Comments of Pacific Gas & Electric Company

Day Ahead Market Enhancement June 20th Technical Workshop

Submitted by	Company	Date Submitted
Simon Ou (415-973-6125)	Pacific Gas & Electric	July 12, 2019

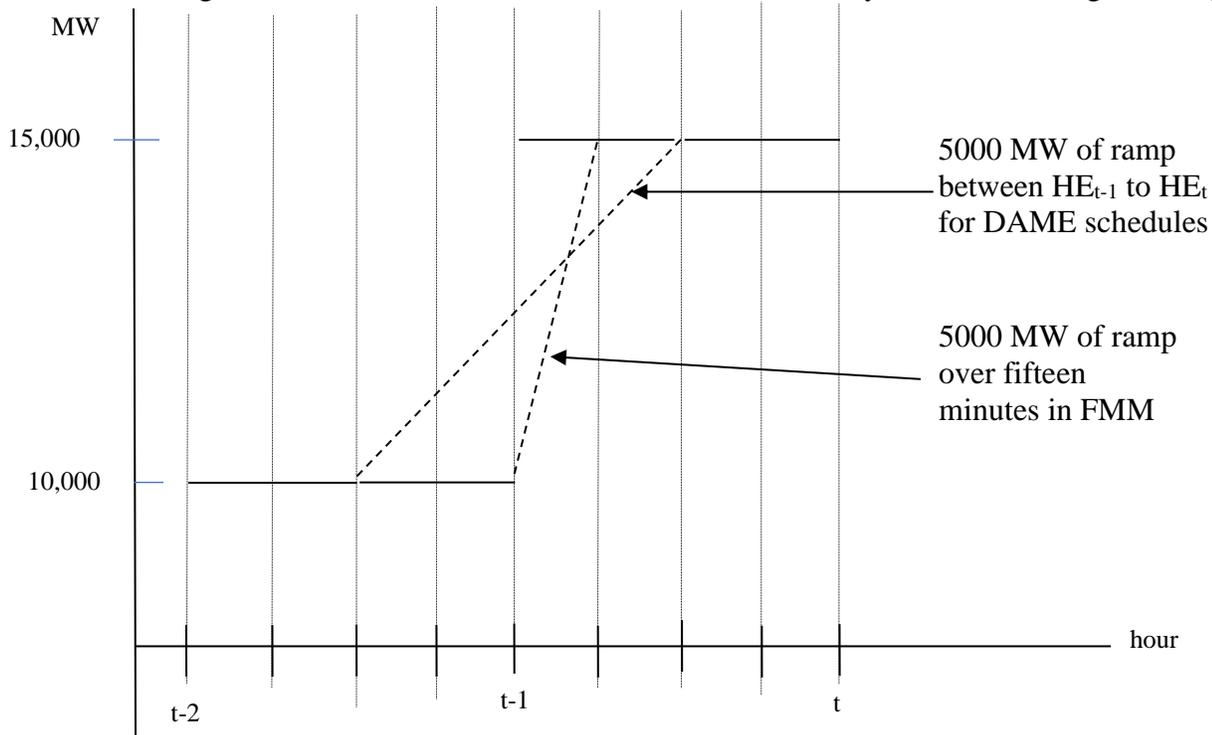
Consider Option 1 and the following illustration. Similar effects exist for Option 2. In this illustration, there is no change in net demand between DAM and FMM. The only difference is in granularity.

Suppose that the CAISO data indicates that the change in demand over the hour in FMM will exactly match the change in demand in DAM over the hour. That is, there will be no uncertainty in demand between DAME and FMM over the hour. However, all of the change is expected to occur in the first 15-minute interval in HET in FMM.

Suppose that the ISO sets $FRUR_t$ to cover the ramp it would need in a 15-minute interval. In the above example, it would require that the market procure sufficient ramp up capability to meet the 15-minute ramp up of 5000 MW in the first fifteen-minute interval with no 15-minute ramp needed for the second, third, and fourth intervals in HET.

That would be 5,000 MW of ramp capability over the hour for the change in schedules in the DAM to meet the change in demand from HET-1 to HET plus an additional 5,000 MW of ramp capability in HET to cover the ramp caused by the 15-minute granularity difference in the first interval. Thus, the model would require 10,000 MW of ramp over the hour which is twice the ramp capability over the hour that is actually needed.

CAISO should consider reformulating the ramp constraints to avoid this issue.
